Design and Access Statement
for
The alterations to the apartment scheme at Victoria Mill,
Miles Platting, Greater Manchester

AllisonPike
Architects and Designers

This design and access statement is submitted in support of applications for key changes to the previously approved apartment scheme for Victoria Mill (application number 119321/JO/2018 submitted by Signature Victoria Mill part of Signature Living).

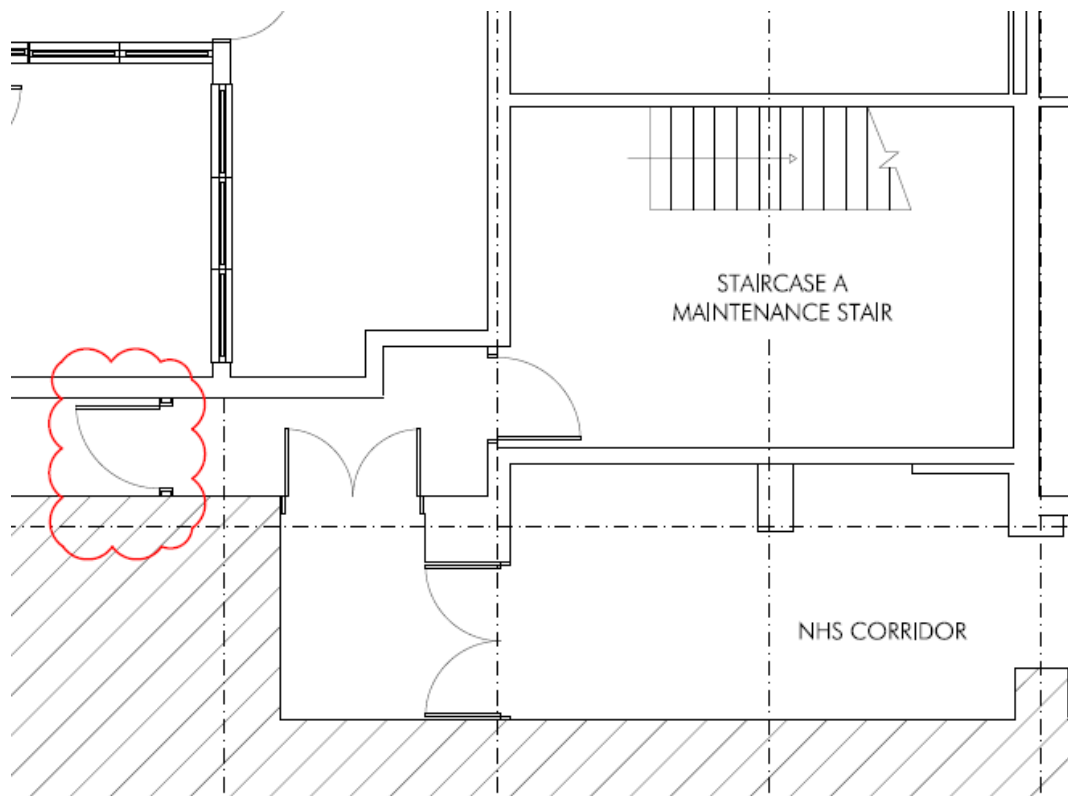
The original scheme housed cycle storage in the existing basement. This was to be accessed by a long ramp and narrow internal corridor. This was viewed to not be very convenient for residents and therefore not be used.

Following discussions with our Secure by Design consultant it was agreed that the best solution to encourage cycle usage was the inclusion of cycle stores on each floor of the building in one of the existing storerooms.

- Secure external cycle storage within the building behind several access-controlled doors
- Cycles can be stored close to residents accommodation

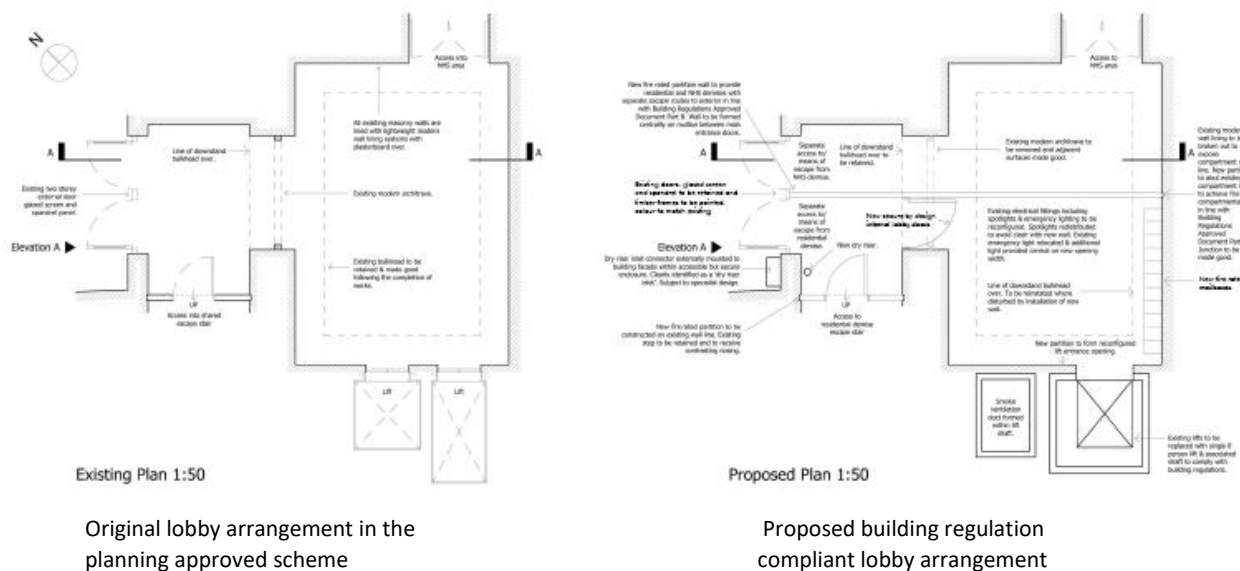
As part of the fire strategy that has been prepared for this building staircase B is required to have an automatic opening smoke vent through the roof. This opening will have minimal impact on the listed building externally as it is in the centre of the plan which has 1400mm approx. high parapet walls to the perimeter, see the roof plan submitted as part of this application.

Location of smoke vent for staircase C

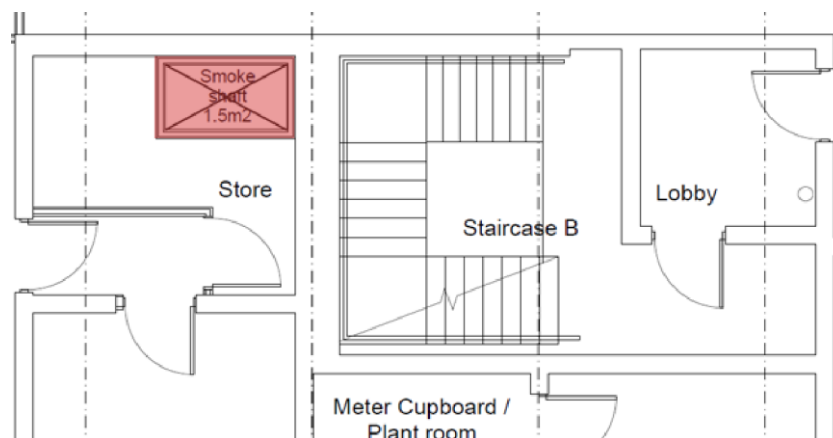
To comply with this building regulation requirement two smoke vents need to be incorporated into the scheme, one to protect each stair. The project's fire strategy document provided by BB7 outlines the ideal location of the smoke shafts as follows; '*the smoke shaft should be located at the remote end of the corridor away from the staircase*'. When considering the location of the shafts the impact on the fabric of the listed building was carefully considered. For the vent to staircase B locating the vent in the redundant staircase A was considered first however, this location proved to be

unworkable because the shaft cannot have any bends in it and due to the location of staircase A in relation to staircase B this fundamental criteria for the shaft would not be met. The remaining area of the core of the building has brick jack arch ceilings and therefore wherever in the core it was to be located an opening in the brickwork would be required. So we have located the shaft in the store room adjacent to the protected corridor to staircase B which complies with the requirements of the British standard. The shaft for staircase C is located one in the disused lift shafts next to the new firefighting lift. This is an existing shaft and does not require any new openings through the floor, only one opening at roof level. The following drawings show the location of the shafts:

Locating the smoke vent for staircase C in the disused lift shaft will have minimal impact on the fabric of the listed building. To create the opening for the smoke vent for staircase B openings will need to be formed in the jack arch brick floor construction at each level. This smoke vent is required in order to make the building safe for a residential use. So whilst installing this shaft will result in some harm to the listed fabric the building as a whole will be protected and maintained long term by full time occupation.

Extract from the third floor GA plan showing the small flight of steps required to link the lift lobby and staircase C

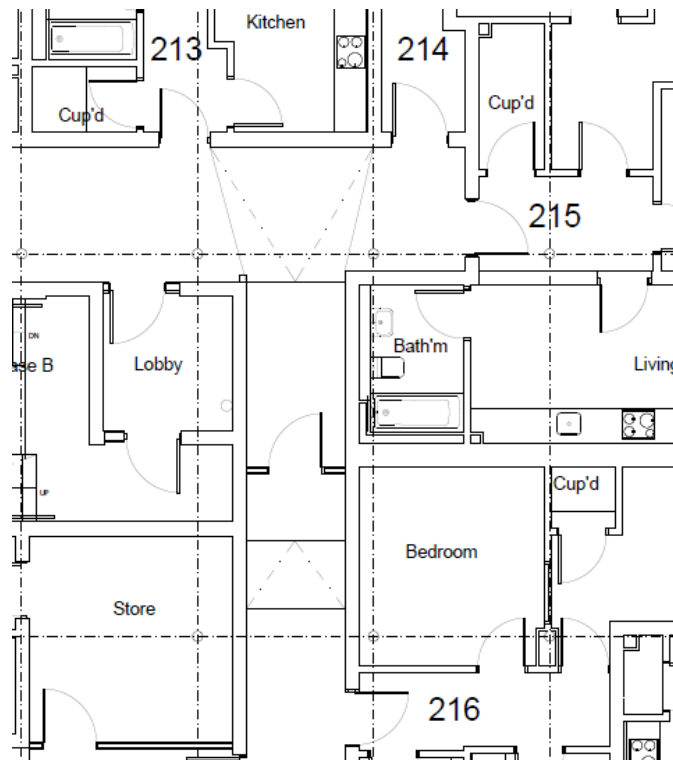
Since starting the construction work it has become necessary to include some additional steps and a ramp to overcome differences in floor levels. At second and third floor a small flight of steps is required between staircase C and the lift lobby, as the following drawing shows:

Typical general arrangement plan with building regulations diagrams above and the required cross corridor door referenced from the building regulation guidance (shown in red),
Diagram provided by BB7 Fire Ltd

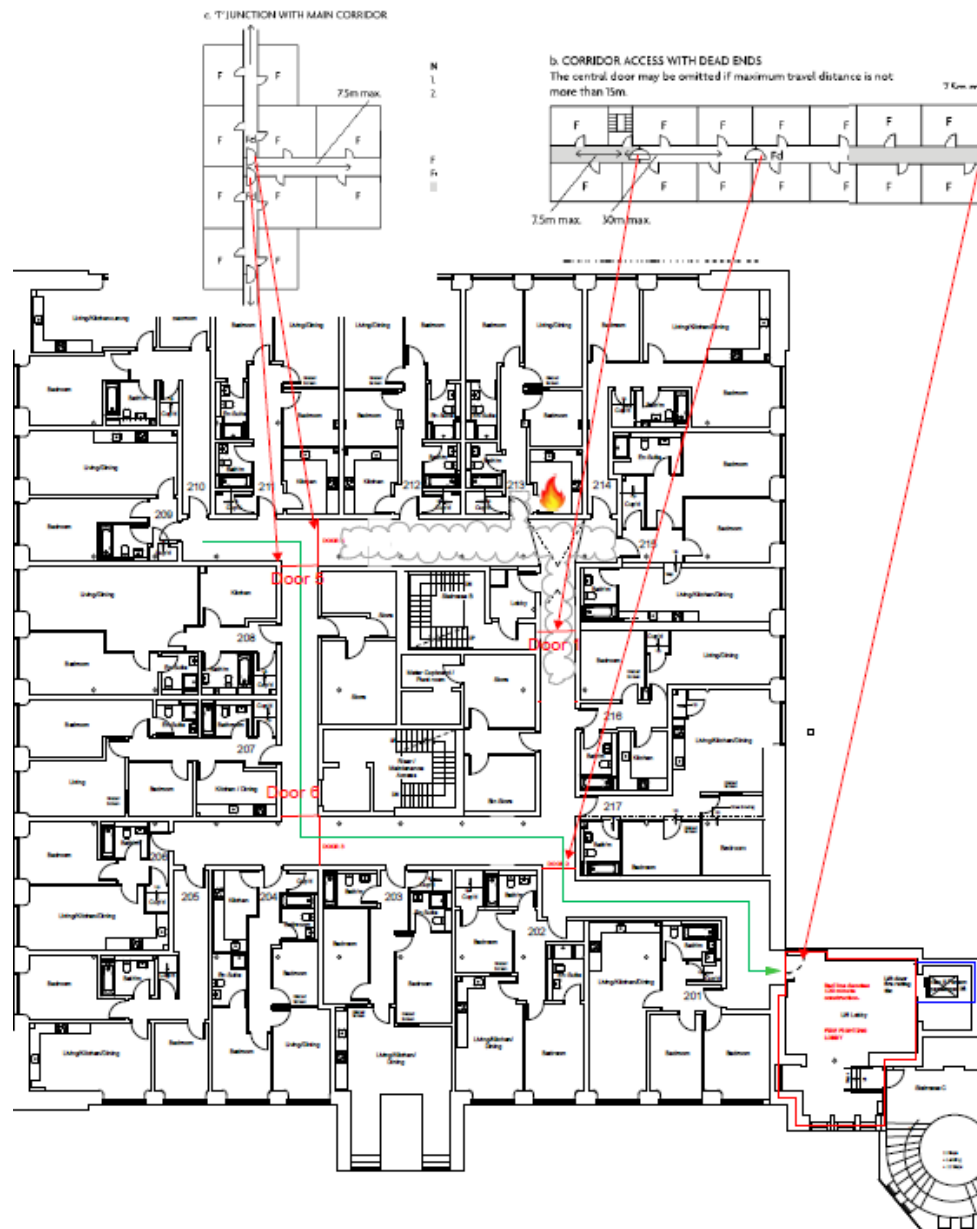
The approved scheme included for two cross corridor doors per floor. The position of these doors were not in accordance with the requirements of Building Regulations Part B Volume 1: Dwellings. There are two dead end corridors in the design and at the end of each one there is a requirement for an alternative protected means of escape. This is described and drawn in both building regulations Part B Volume 1 for Dwellings and the British Standard BS9991:2015. The figure below shows the diagrams from the building regulations referenced to the specific design of Victoria Mill as provided by the project appointed fire engineer BB7 Fire Limited. This is a necessary change in order to use this building for a residential purpose.

Extract of the ground floor plan showing the corridor from staircase B with an additional door added (highlighted in the red revision cloud)

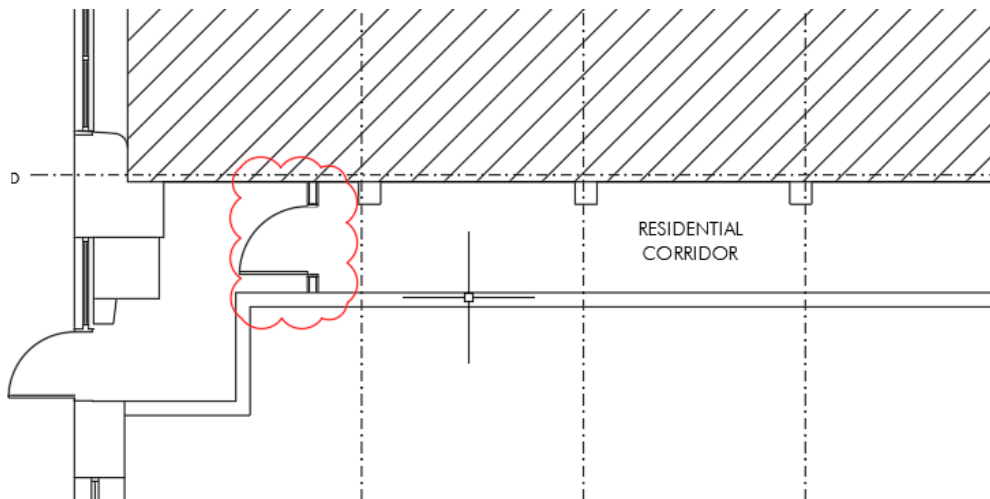
In order to comply with Secure by Design requirements the rear ground floor fire exit door needs to be made secure. The existing external door is listed therefore it was proposed that an additional internal Secure by Design door would be added to comply with this requirement, see the following drawing extract. This has been agreed with the Secure by Design consultant and is required to achieve accreditation.
